# UNITED STATES PATENT AND TRADEMARK OFFICE

APPLICATION NO.	FILING DATE	FIRST NAMED INVENTOR	ATTORNEY DOCKET NO.	CONFIRMATION NO.
10/090,741	03/06/2002	Jun Miyokawa	219404US8	5255
22850	7590	10/28/2003	EXAMINER	
OBLON, SPIVAK, MCCLELLAND, MAIER & NEUSTADT, P.C. 1940 DUKE STREET ALEXANDRIA, VA 22314			WONG, ERIC K	
			ART UNIT	PAPER NUMBER
			2874

**Office Action Summary**

**Reproduced from Reference Katayama et al.**

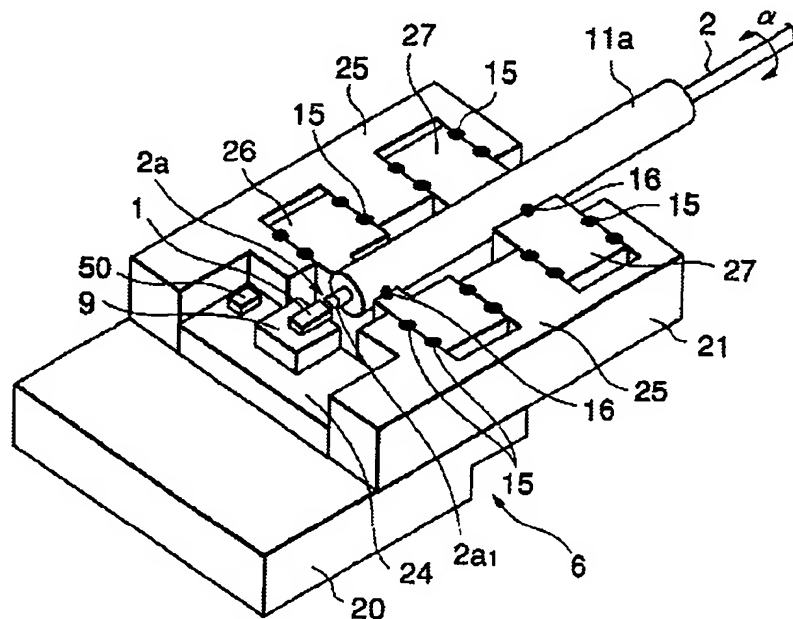
As to claims 1, 2, 3, 5, 6, 8, 9, 10, 11, and 20, Katayama discloses in figure 5A, a semiconductor laser module comprising:

- A semiconductor laser configured to emit light (1);
- An optical fiber having a tip end portion opposing said semiconductor laser and formed in a lens shaped configuration so as to optically couple light emitted from said laser (2a);

- An optical fiber supporting member configured to support said optical fiber (11a);
  - A first fixing block and a second fixing block portion positioned on opposite sides of a supporting member (26),

- A first bridge portion (where 16 welds),
  - A second bridge portion (opposite 16), and
  - As to claim 4, a group of fixing members (26, 27) are present which hold a fiber ferrule in place,

- As to claim 7, the first and second fixing members are non-integral as they need to be welded,
  - As to claim 12, the base includes a semiconductor laser-mounting member (9) and a fixing-member mounting member provided on the semiconductor laser mounting member,

- As to claim 13, said semiconductor-laser mounting member and base are integrally formed as a single member (1, 9 and 24),
  - As to claim 14, the first fixing-member mounting member has a first recessed portion corresponding to a first fixing block portion and a second recessed portion corresponding to a second fixing block so as to fix the first and second by respective recessed portions (25),
